APPLICATION NO.	FILING DATE	FIRST NAMED INVENTOR	ATTORNEY DOCKET NO.	CONFIRMATION NO.
10/801,842	03/16/2004	William C. Phelps III	IS01508ESG	3107
20280	7590	10/23/2006	EXAMINER	
MOTOROLA INC 600 NORTH US HIGHWAY 45 ROOM AS437 LIBERTYVILLE, IL 60048-5343			STERLING, AMY JO	
			ART UNIT	PAPER NUMBER
			3632

This is a non-final Office Action for application number 10/801,842 Electronic Device Cradle having Replacement Latches, filed on 3/16/04. Claims 1, 2, 4-19 are pending. Claims 10-19 are withdrawn. The text of those sections of Title 35, U.S. Code not included in this action can be found in a prior Office action.

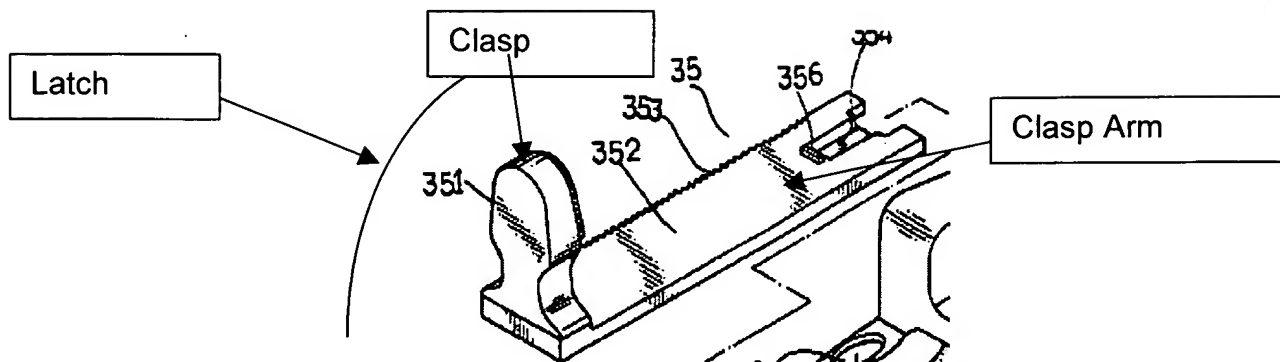
Claims 1-9 are rejected under 35 U.S.C. 102(e) as being anticipated by United States Patent No. 6816713 to Chen.

The patent to Chen discloses a cradle and latch assembly having a body (10, 20), the body having at least one pocket (21), at least one latch aperture (241) and a latch (35) detachable from the body, the latch having a clasp (351) and a means for coupling (353, 354, 356) to the body and a clasp arm (352, 356, 354) having a clasp arm length wherein the latch (35) is detachable from the body (10, 20) wherein the clasp extends in a non-coplanar angle from a portion of the clasp arm.

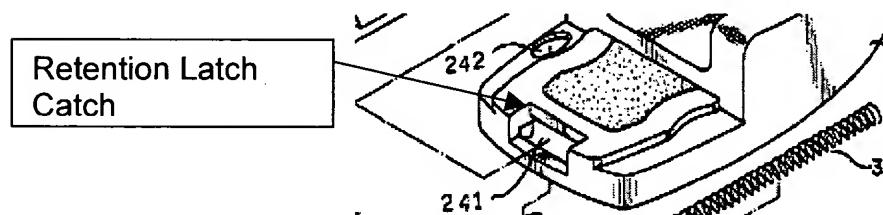
Chen also discloses wherein the means for coupling includes a retention latch (354, 356) including a retention latch arm (354) wherein the retention latch arm (354) acts as a cantilever beam and wherein the latch has a thumb release (31) coupled to the clasp arm and the clasp arm deforming in response to receiving a force at the thumb release, a stabilizing support (33) and a rear support (36) and wherein the body has a retention latch catch (the upper lip of the area surrounding the latch aperture, which catches the retention latch 356, See Drawing Below), a rear support recess (11), a latch guide (246) and a rotation support (22, 23).
